Summary of IEEE Std 1588TM – 2008 Optional Features Related to Redundancy and Potentially Improved Performance

IEEE 802.1 TSN TG
2013.05.14

MDSyncReceiveSM State Machine

Reproduced from Figure 11-6/802.1AS

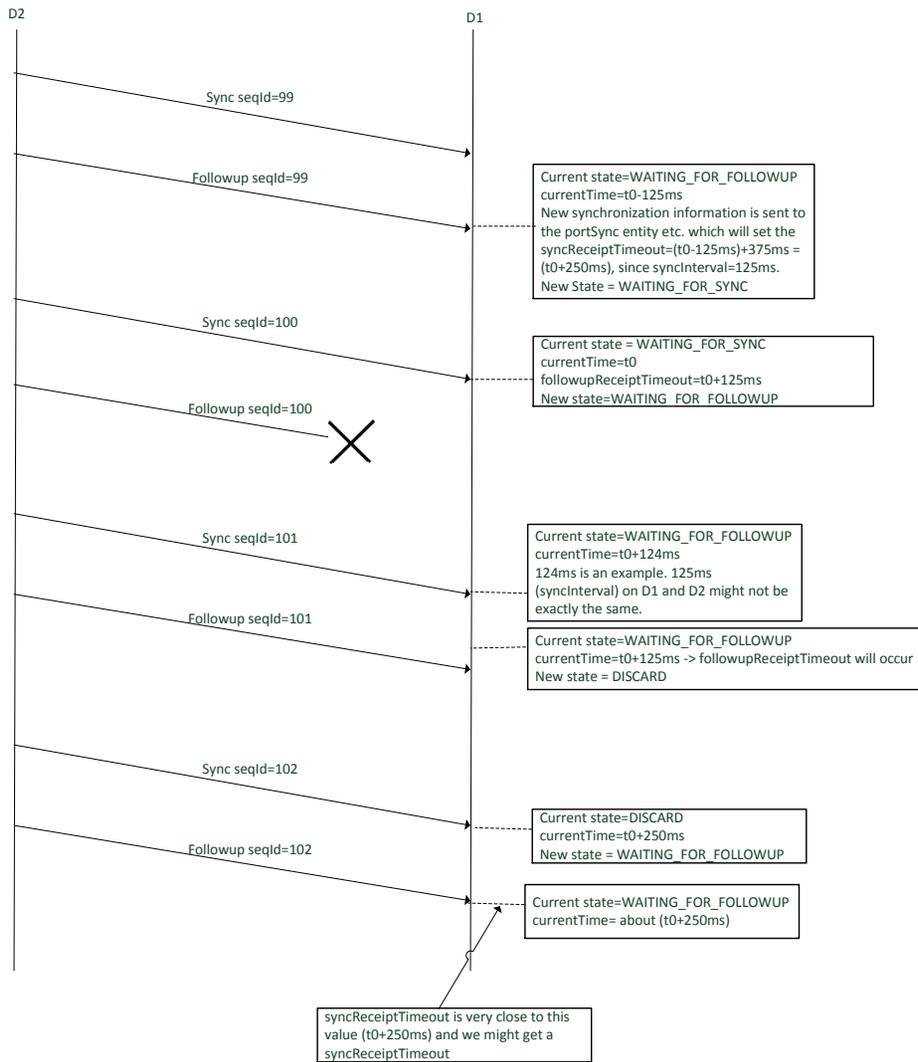
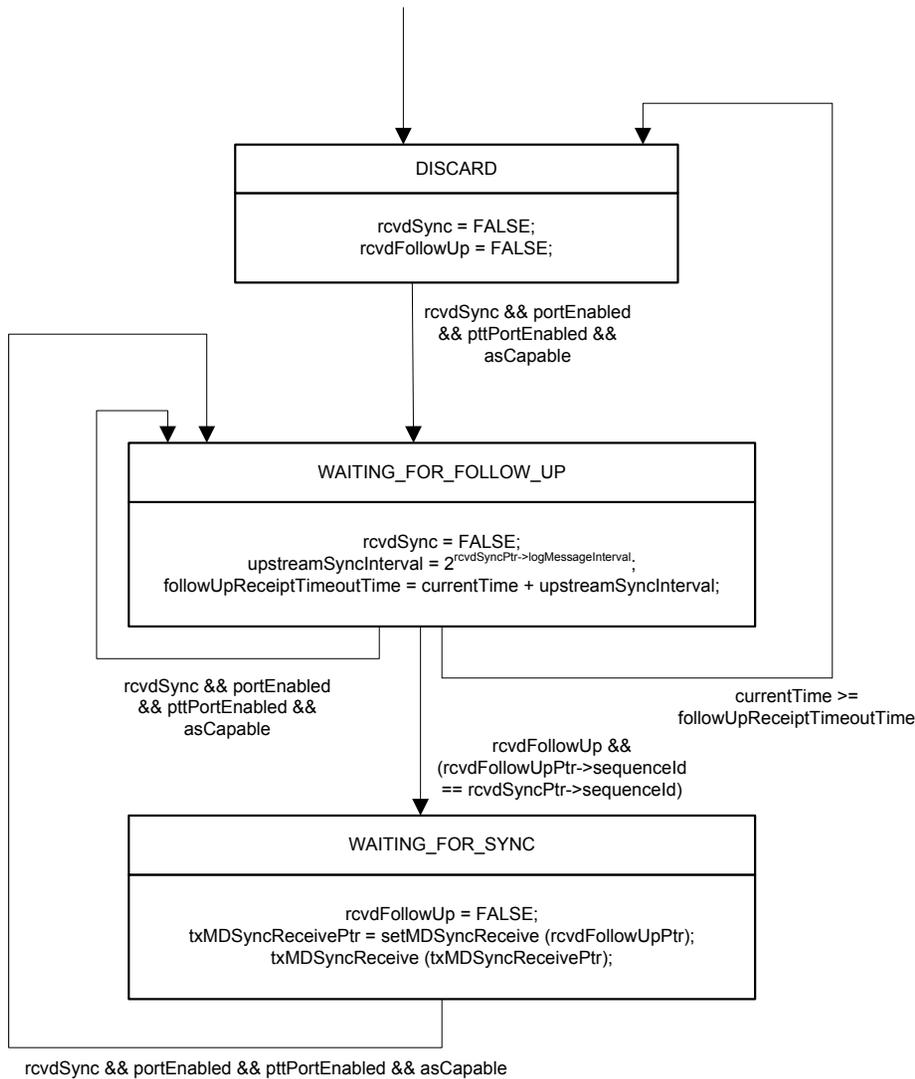
- It was suggested in the June 19, 2013 TSN call that a simple fix would be to declare a Follow_Up message lost if it has not arrived by the time the next Sync message arrives
- This is reasonable, because a sender sends Follow_Up corresponding to the most recent Sync message it has sent before sending the next Sync message
 - This is implied by the MDSyncSendSM state machine (see Figure 11-7/802.1AS-2011)
 - The order of the frames will not change on the link between the sender and receiver, which means that Follow_Up corresponding to a Sync message should arrive before the next Sync message
- This fix can easily be incorporated
 - See next slide for the revised MDSyncReceiveSM State Machine

- Aside from the issue discussed in this presentation, the current state machine is in error with respect to its current behavior
 - If the state machine is in the WAITING_FOR_FOLLOW_UP state and a new Sync is received before the FOLLOW_UP corresponding to the current Sync, then

- rcvdSync will be set to TRUE
 - rcvdSyncPtr will now point to the new Sync that is received
 - If the Follow_Up corresponding to the current Sync is now received, the test `rcvdFollowUpPtr->sequenceid == rcvdSyncPtr->sequenceid` will fail because `rcvdSyncPtr` points to the new Sync while `rcvdFollowUpPtr` points to the Follow_Up corresponding to the old Sync

- To achieve the desired old behavior (i.e., keep waiting for the Follow_Up, even if a new Sync arrives first), `rcvdSyncPtr` should have been saved, and the saved value used in the test on `sequenceid`

- ❑ Add a branch out of the **WAITING_FOR_FOLLOW_UP** state back to itself, with the condition `rcvdSync && portEnabled && pttPortEnabled && asCapable`
- ❑ If a new Sync message is received before either **Follow_Up** for the current Sync is received or `followUpReceiptTimeoutTime` is reached, the **WAITING_FOR_FOLLOW_UP** state is reentered and the `followUpReceiptTimeoutTime` is reset

- ❑ The revised MDSyncReceiveSM State Machine on slide 11 achieves the behavior suggested in the June 19, 2013 TSN call, and fixes the issue described here
- ❑ If this is acceptable to the TSN TG, this change can be inserted into the first 802.1ASbt draft

Scenario leading to sync receipt timeout - 1

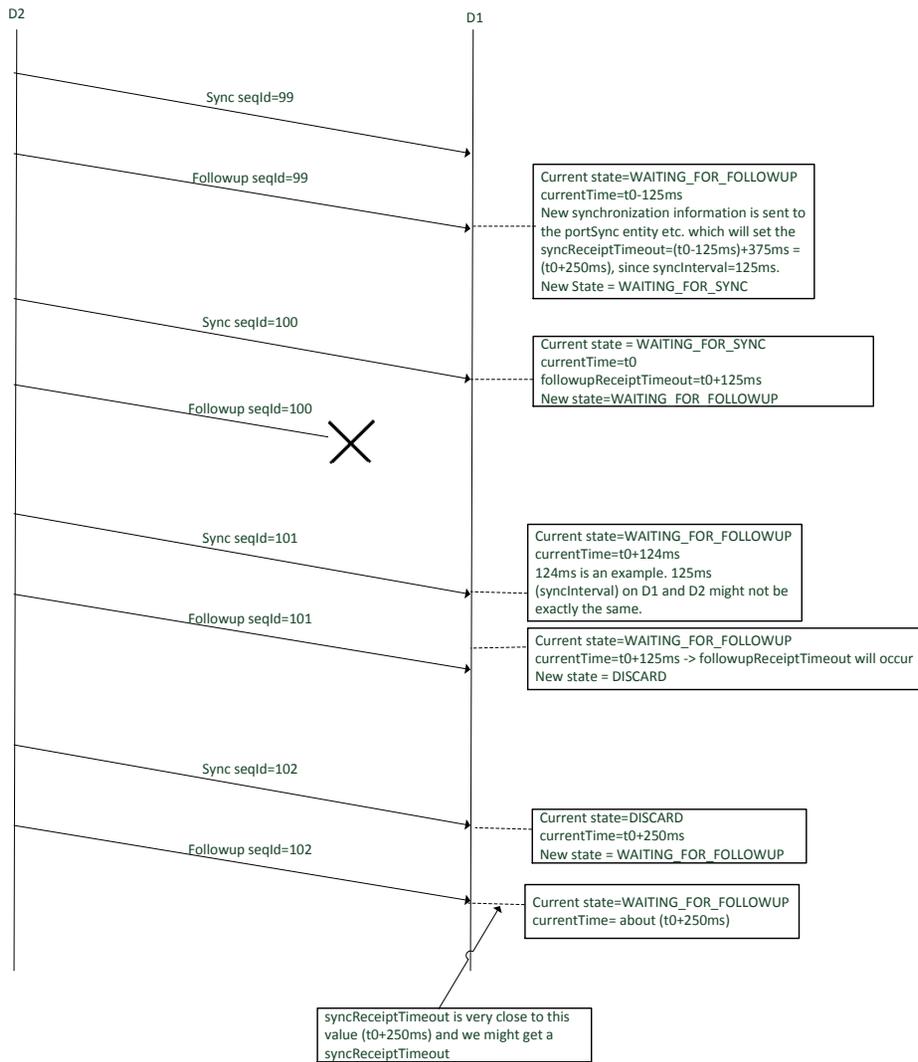
- ❑ Sync interval = 125 ms
- ❑ Sync receipt timeout = 3 sync intervals
- ❑ Sync message 99 arrives; go to state `WAITING_FOR_FOLLOWUP`
- ❑ Follow_Up message 99 arrives at time t_0-125 ms; go to state `WAITING_FOR_SYNC`
 - Information is sent to PortSync entity, and PortSyncSyncReceiveSM sets `syncReceiptTimeoutTime` to `currentTime+375 ms = t0+250 ms`
- ❑ Sync message 100 arrives at time t_0 (slightly late since it is more than 125 ms later than previous Sync); go to state `WAITING_FOR_FOLLOWUP`
 - `followUpReceiptTimeoutTime` set to t_0+125 ms by MDSyncReceiveSM
- ❑ Follow_Up message 100 is lost
- ❑ Sync message 101 arrives at time t_0+124 ms, i.e., slightly early
 - It is ignored, because MDSyncReceiveSM is still waiting for Follow_Up

- ❑ At time t_0+125 ms, followUpReceiptTimeout occurs; go to state DISCARD
- ❑ Follow_Up message 101 arrives, and is ignored because Sync message 101 was not processed
- ❑ Sync message 102 arrives at time t_0+250 ms; go to state WAITING_FOR_FOLLOWUP
 - followUpReceiptTimeoutTime set to t_0+375 ms by MDSyncReceiveSM
- ❑ Follow_Up message 102 will arrive between t_0+250 ms and t_0+375 ms
 - However, syncReceiptTimeoutTime is set to t_0+250 ms
- ❑ Therefore, sync receipt timeout occurs at time t_0+250 ms
 - Sync receipt timeout has occurred, even though only one Follow_Up message has been lost

- a) After initial Follow_Up message was lost, the MDSyncReceiveSM continued to wait for the Follow_Up, for the remainder of the interval until followUpReceiptTimeoutTime
- b) Since the Follow_Up receipt timeout interval is equal to the Sync interval, this meant that the state machine waited until the next Sync interval
- c) Unfortunately, the next Sync arrived slightly early; it was ignored because the state machine does not process the next Sync until it is finished processing the current Sync (or has declared the current Sync or Follow_Up lost)
 - It was decided early in the development of 802.1AS not to require processing of multiple outstanding Follow_Up messages (for multiple Sync messages), to avoid complexity; this behavior is desired
